Re: LeBreton Flats Library Parcel – 665 Albert Street, City of Ottawa
Booth Street and Albert Street NE Roadside Safety Assessment
TYLin Ref. 10399

MEMORANDUM

LSU	
Width	: 2600 mm
Track	: 2600 mm
Lock to Lock Time	: 6.0
Steering Angle	: 40.3

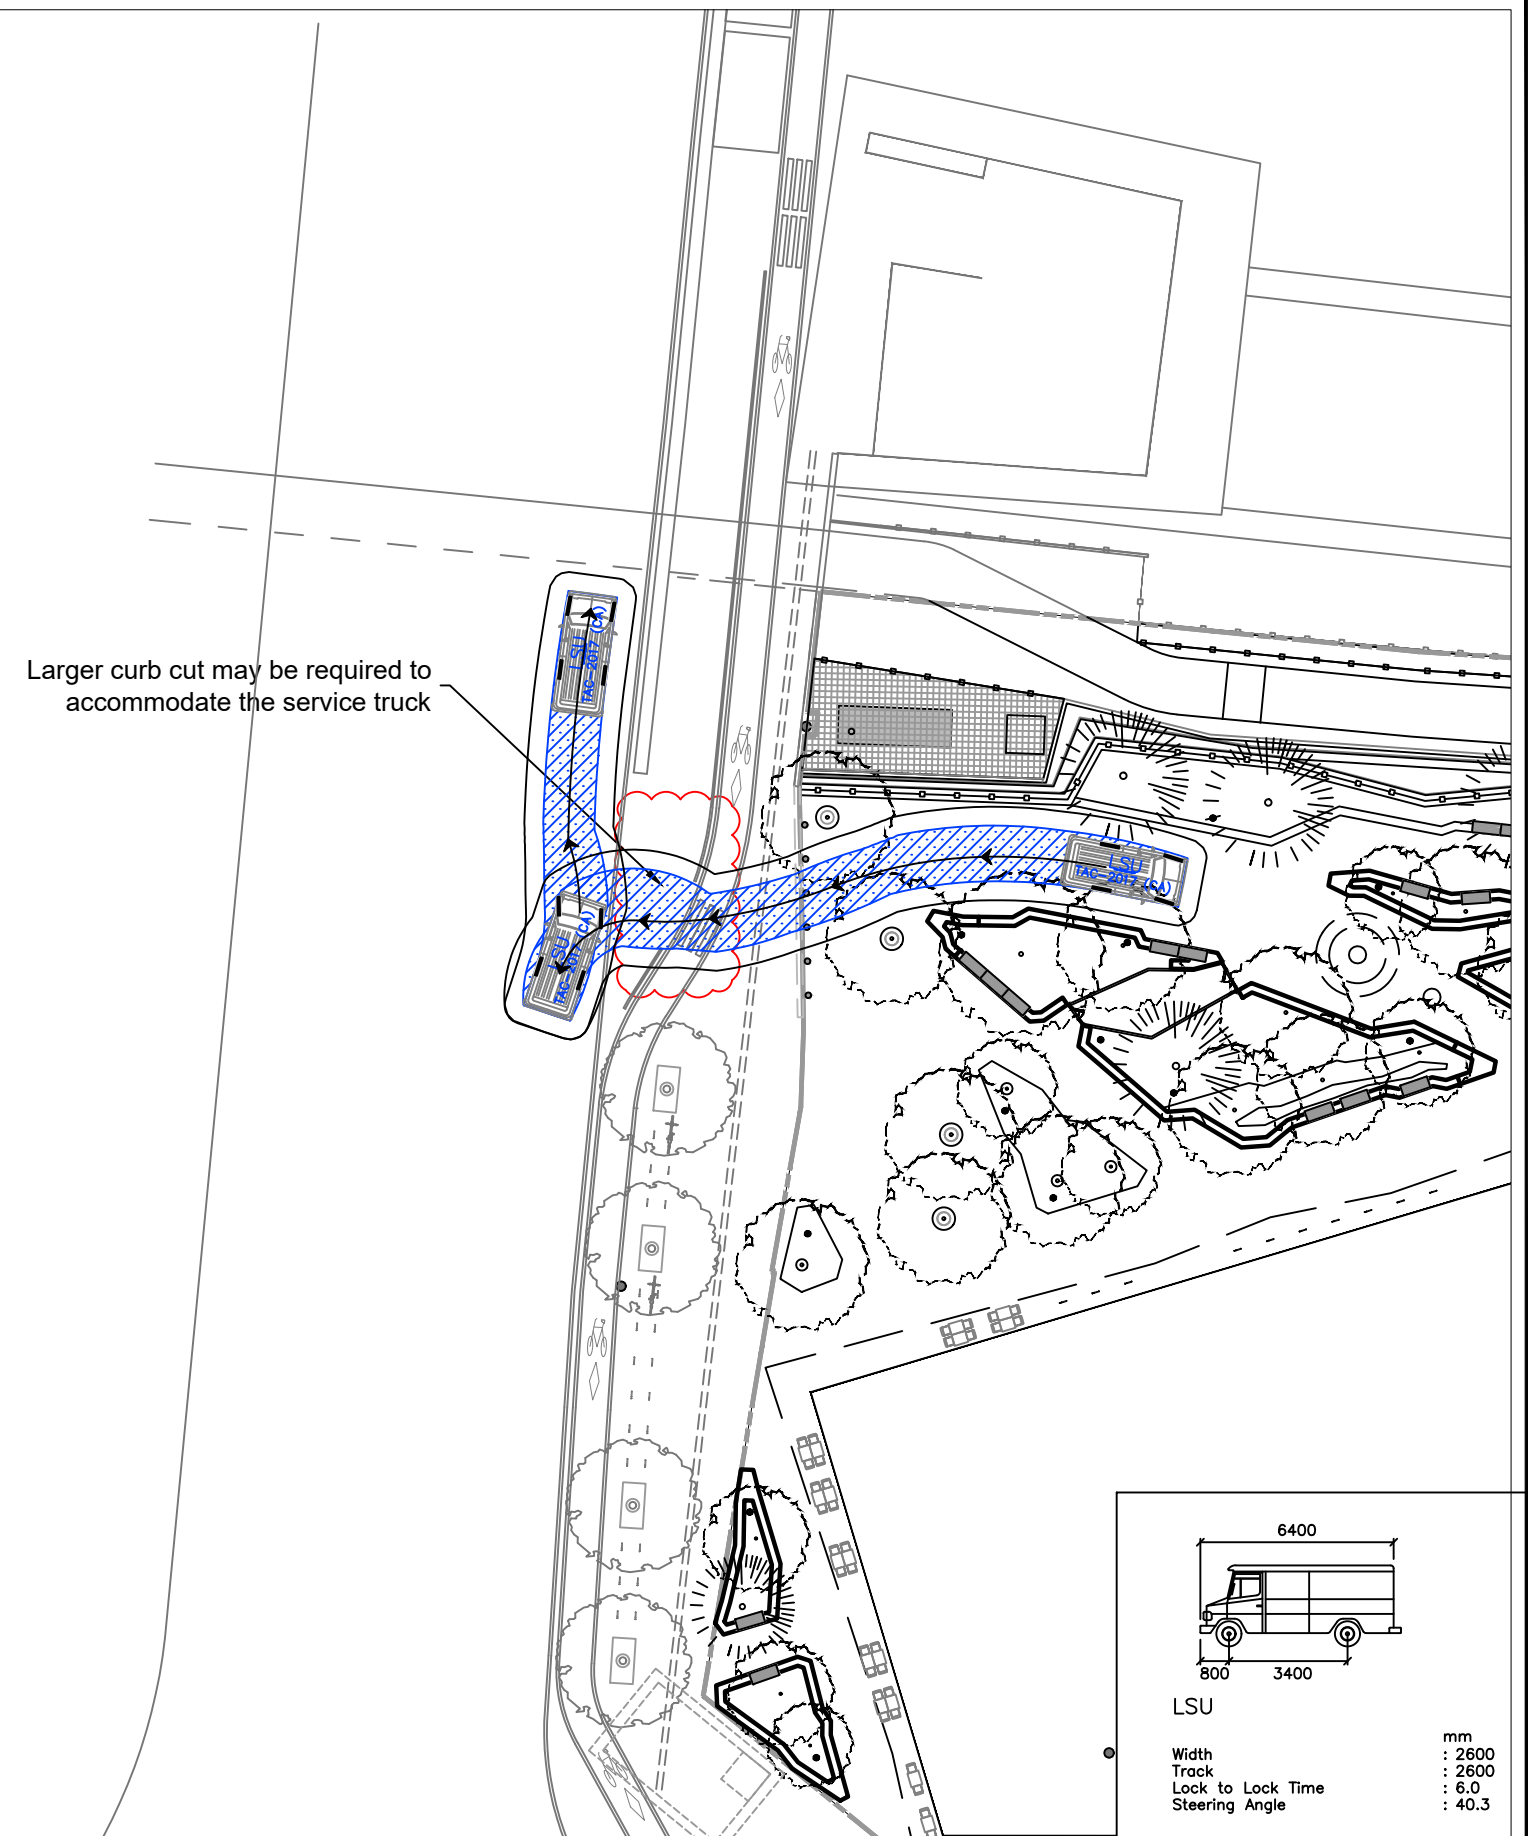
Please note that the design vehicle used for the simulation may be different than the operating vehicle. It is our understanding that two small vans will also access the site. A typical delivery truck (TAC-LSU) was used for this exercise. Please confirm with the design vehicle's dimensions and specs.

- 1.0m horizontal buffer was considered throughout the truck swept path
- It is strongly recommended that trained staffs from the city or property management staffs be present to assist circulation of the service truck. The truck will reverse in to the pedestrian realm from a public road, therefore vulnerable users shall be warned during this operation.

Larger curb cut may be required to accommodate the service truck

Larger curb cut may be required to accommodate the service truck
